Access Compliance Report

Public Rights-of-Way

(Curb Ramps)

Intersection ID: 15211	Main Street: EAST_BV	Cross Street: SCOTT_AV	Location: S
ADA ID: 17D24F80CC9D	Ramp Type: BlendTrans2	Initial Pass/Fail: Fail	Overall Compliance: No
Severity Score: 25			
Codes/Mitigation Info/Possible Solution		Field Measurements/Component Compliance

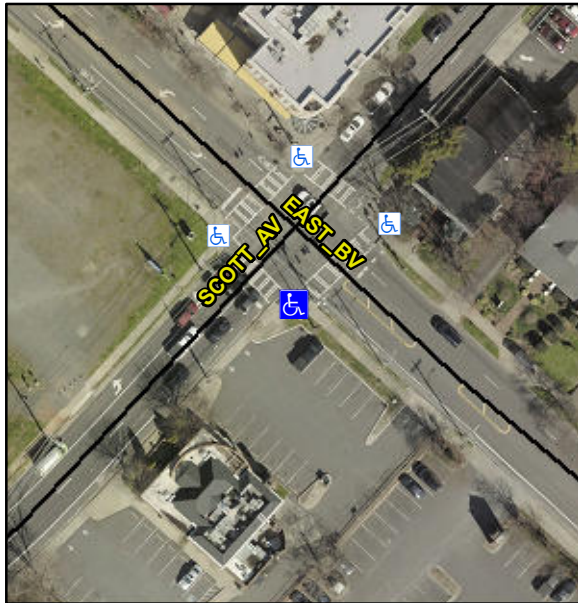
Not Found, R304.5.3

Compliance	Description	Data	Compliance	Description	Data
N/A	Ramp Length (in)	135.0	Yes	BlendTrans Slope (%)	4.8
Yes	Ramp Width (in)	132.0	No	BlendTrans XSlope (%)	11.6
N/A	Flare Type LT	N/A	N/A	Flare Type RT	N/A
N/A	Flare Slope LT (%)	N/A	N/A	Flare Slope RT (%)	N/A
N/A	Flare Traversable LT?	N/A	N/A	Flare Traversable RT?	N/A
N/A	Landing Length (in)	N/A	N/A	DWS Provided?	N/A
N/A	Landing Width (in)	N/A	N/A	DWS Contrast?	N/A
N/A	Landing Slope (%)	N/A	N/A	DWS Length (in)	N/A
N/A	Landing X Slope (%)	N/A	N/A	DWS Full Width?	N/A
N/A	Landing Curb? (Y/N)	N/A	N/A	DWS Offset (in)	N/A
N/A	Shared Landing?	N/A			
N/A	Gutter Ponding?	N/A	N/A	Gutter Slope (%)	N/A
N/A	Gutter Lip Ht (in)	N/A	N/A	Gutter X Slope (%)	N/A
N/A	Painted X Walk1?	Yes	N/A	Painted X Walk2?	Yes
	X Walk 1 Direction	To NE		X Walk 2 Direction	To NW
	X Walk 1 Width (in)	113.0		X Walk 2 Width (in)	106.0
	X Walk 1 Slope (%)	4.3		X Walk 2 Slope (%)	0.8
	X Walk 1 X Slope (%)	2.7		X Walk 2 X Slope (%)	2.3

N/A	Ramp inside XWalk1?	Yes	N/A	Ramp inside XWalk2?	Yes
	Road Slope (%)	3.5		Clear Space?	N/A
	Road X Slope (%)	1.6	N/A	Clear Space to XWalk (in)	N/A
N/A	Any Obstructions?	N/A	N/A	Storm Grate/Utility Hazard?	N/A
	Obstruction Type			Storm Grate/Utility Type	
		N/A			N/A
		Yes		Surface Condition? (G/P)	Good
		No		Curb Slope (%)	6.0

Remove & Replace Curb Ramp With Two New Directional Ramps or Equivalent.
